**Staff Report: Preliminary Plan Amendment 11999100A: Chevy Chase Bank at Cloverly
 Site Plan 820080200: Chevy Chase Bank at Cloverly**

MCPB HEARING DATE: March 19, 2009

Proposal for a Preliminary Plan Amendment and Site Plan to create one 34,104 square foot (0.78 acres) lot for a 3,172 square foot bank with drive-thru, in the C-1 Zone; located on New Hampshire Avenue (MD 650) approximately 220 feet northeast of the intersection with Cloverly Street within the Cloverly Master Plan Area.

Illustrative Plan

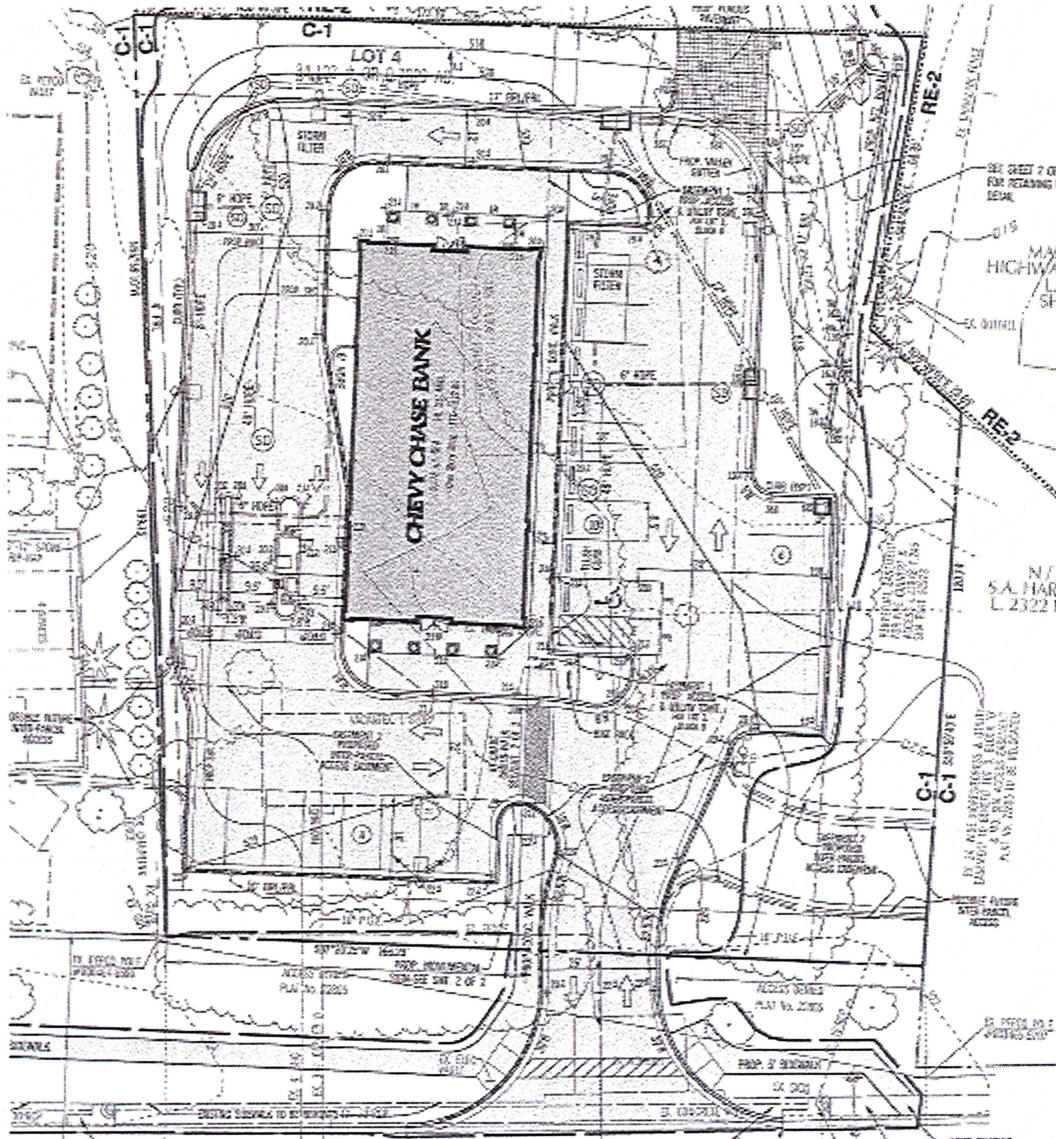
The application meets the applicable recommendations of the Master Plan listed above, except for items 1, and 4. Although the bank's front entrance is facing New Hampshire Avenue, it is not possible to both provide the interconnection to adjacent commercial properties and create a street-oriented building. The adjoining commercial property is currently developed as a small shopping center, and it is not likely to redevelop in the foreseeable future. Furthermore, the property owner is adamantly opposed to allowing a physical connection to the bank property and will not consent to the connection. Therefore, staff is recommending creation of an easement across the front of this

property that will facilitate future interconnection with the adjacent properties if or when they redevelop. This easement, and the need to provide primary access to the Subject Property from New Hampshire Avenue, limit the ability to locate the proposed bank building closer to the road, and in staff's opinion, the proposed layout is the best way to accommodate future connections and provide adequate circulation for the proposed use. Since the building is not proposed to be located close to New Hampshire Avenue, the Applicant is proposing to locate a sign on New Hampshire Avenue. The proposed sign is a 6.5 foot high internally illuminated monument sign accented with landscaping, rather than a tall, highway-oriented, pole mounted sign.

In an effort to meet the recommendations of the Master Plan the Applicant has pulled the building back to accommodate the future possibility of interconnection between the C-1 zoned properties. This shifts some of the parking to the front of the building; however, the Applicant is proposing to provide adequate landscaping to effectively screen the parking from New Hampshire Avenue. The Applicant is also proposing to significantly improve the pedestrian environment and provide more orderly access to the Cloverly Commercial Area. The Applicant is proposing to relocate the sidewalk along the entire property frontage, and extend these improvements to the adjacent commercial property driveway to the south. A 15-foot green panel would be installed along New Hampshire Avenue between the curb and the new sidewalk. The Applicant will also plant street trees along the frontage of the property. The proposed sign with appropriate landscaping adds to the pedestrian scale, and staff finds that the sign meets the recommendation of the Master Plan.

- 3) The certified preliminary plan must delineate the ingress/egress and utilities easement for the church property to the west of the Subject Property, and the access easement for future connection to the adjacent commercial properties.
